**From:** chrisval matteson <[REDACTED]>  
**Sent:** Monday, November 14, 2022 2:11 PM  
**To:** Carlos Serna  
**Cc:** chrisval matteson  
**Subject:** [External]Proposed Camburn & Central New Shopping Plaza Concerns  
**Attachments:** 20221004\_210619.jpg; 20221114\_083059.jpg; 20221114\_120458.jpg

**From:** David McLean <[REDACTED]>  
**Sent:** Monday, November 14, 2022 7:24 PM  
**To:** Carlos Serna  
**Subject:** [External]Evergreen commercial Development

This is regarding the traffic study in the Mitigated Negative Declaration for the Evergreen project,

**From:** Nick Lowe  
**Sent:** Monday, April 3, 2023 1:53 PM  
**To:** Damaris Abraham  
**Cc:** Remon Habib  
**Subject:** Evergreen Traffic Response

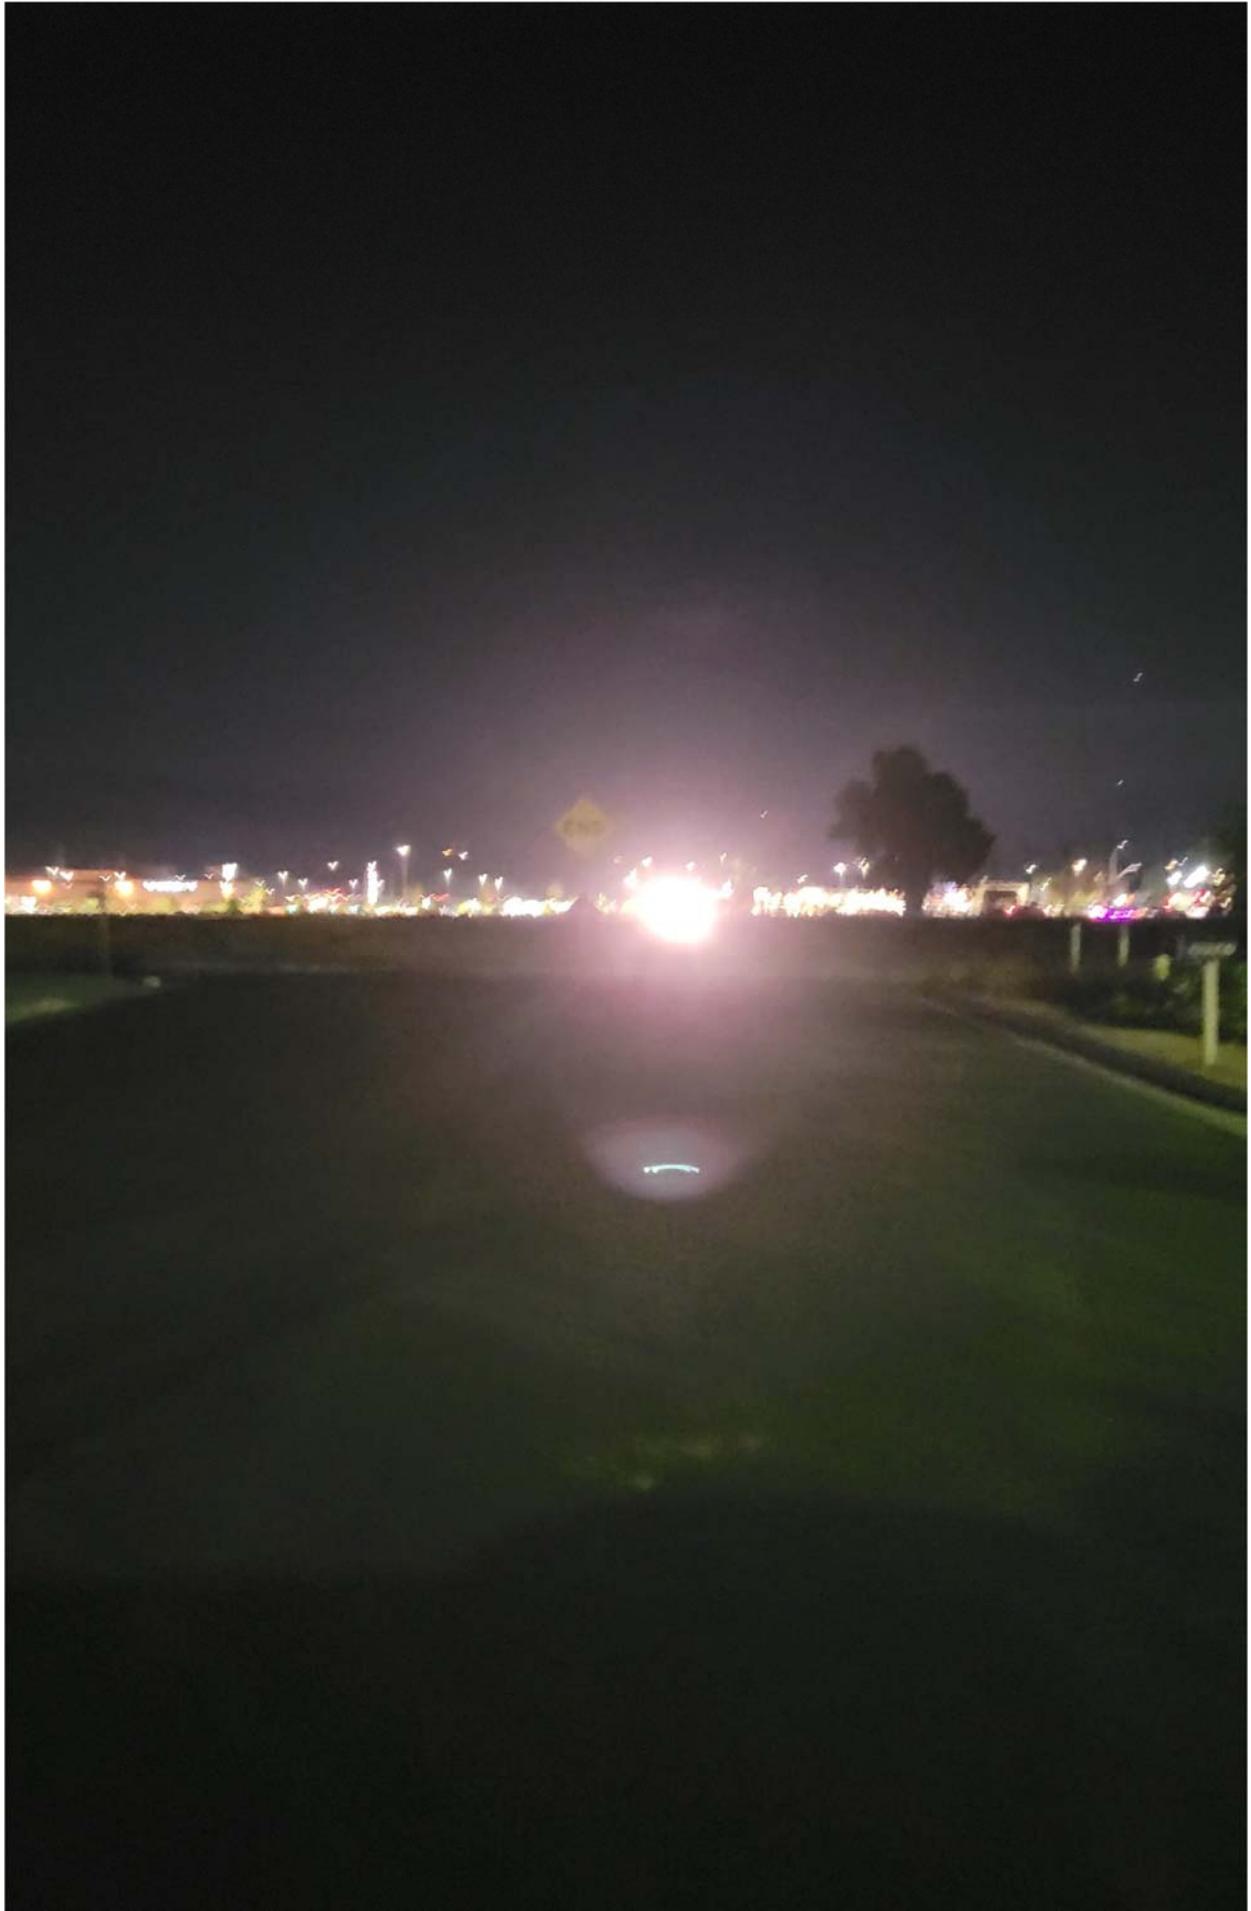
Attached is a picture of the **NON-STOP GLARE / LIGHT POLLUTION** we are already getting from the Walmart parking lot car egress all the way from the other side of Camburn

Attached is a picture of another parking lot gate with metal mesh screening on one side to help minimize light on neighbor's windows

# GATE IN PROPERTY LINE SCREENING WALL

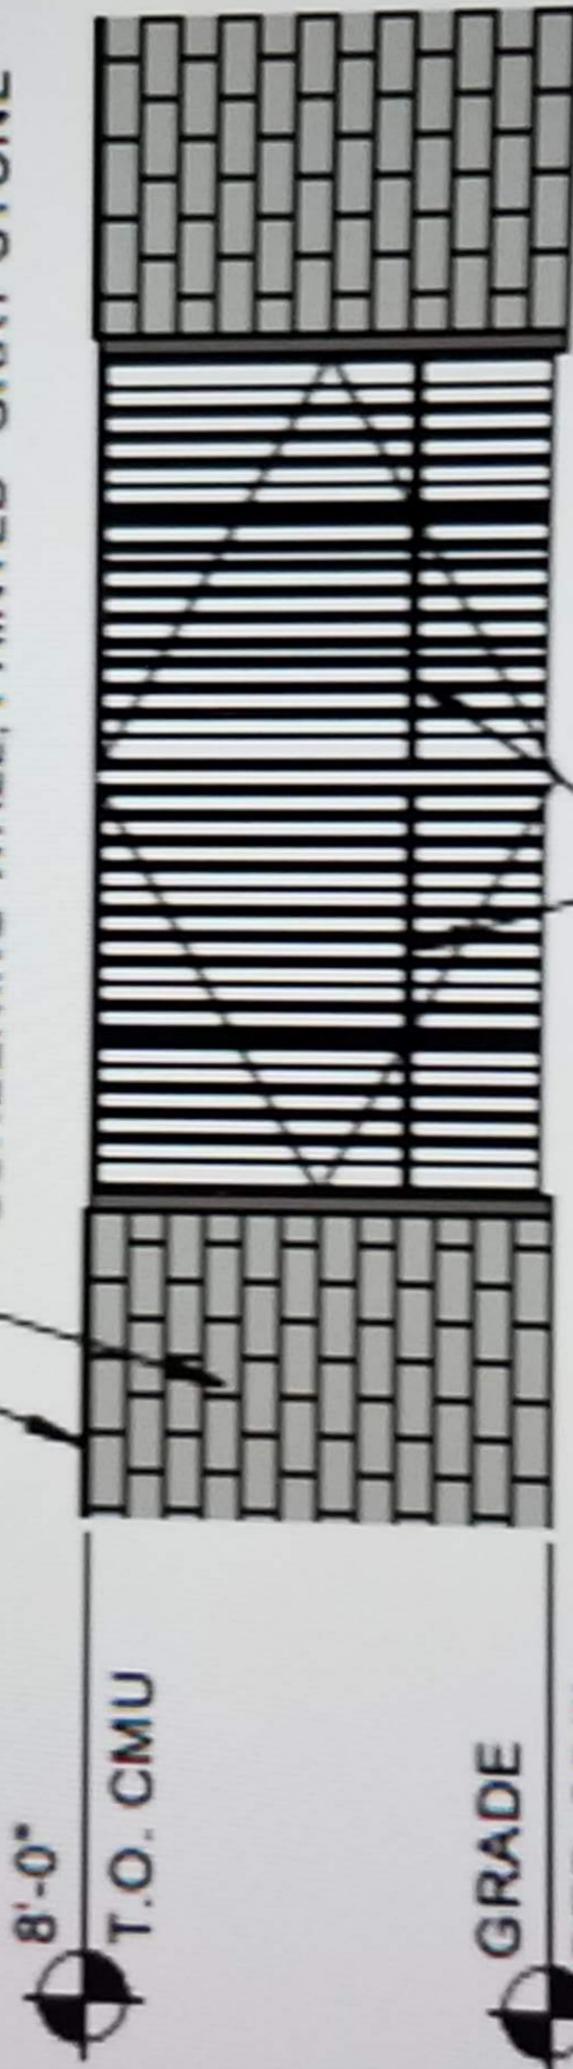
Evergreen Development showed us a rendering of the type of wrought iron gates they are planning

These gates as designed will allow even more unlimited and unrestricted light pollution from the new parking lot to shine down our street non-stop

Could you maybe take it a step further and **require VERY FINE metal screen mesh (not so transparent) and on BOTH SIDES of the gates** to further minimize the light passing through?
